Docket Number:	06-AFC-07C
Project Title:	Humboldt Bay Generating Station - Compliance
TN #:	219972
Document Title:	Petition to Amend Data Request Response
Description:	Air Quality
Filer:	Mineka Foggie
Organization:	California Energy Commission
Submitter Role:	Commission Staff
Submission Date:	6/29/2017 9:38:29 AM
Docketed Date:	6/29/2017

HBGS Air Quality Petition to Amend Data Request Response

Figure 9a: Active Schools in 2008

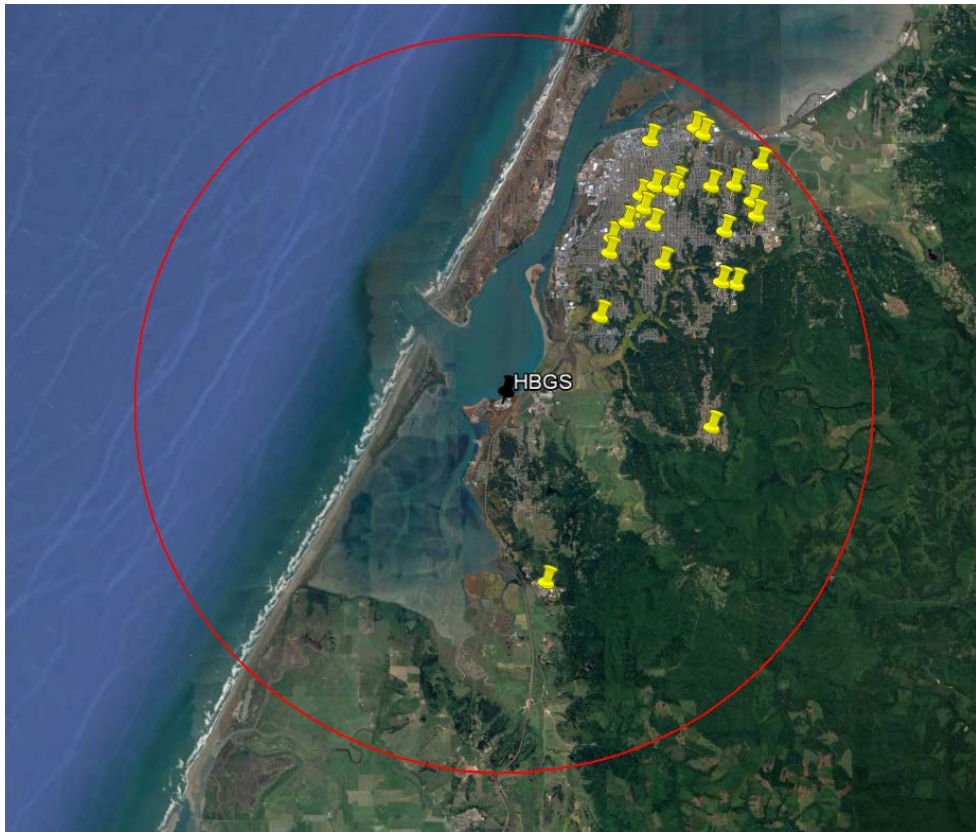
9. Please investigate and describe any change in populations that have occurred since September 2008 within 6 miles of the HBGS, including sensitive receptors (schools, day care facilities, hospitals, nursing homes, etc.) and Environmental Justice communities. Please provide the results of this investigation with appropriate tables and maps.

were active in the years 2008 and 2016. Figure 9a maps the schools which were active in 2008 and Figure 9b maps the schools which were active in 2016. In each figure, the black pin indicates the location of HBGS, the yellow pins represent each school listed in Table 9a, and the red circle represents a radius of six miles surrounding HBGS.
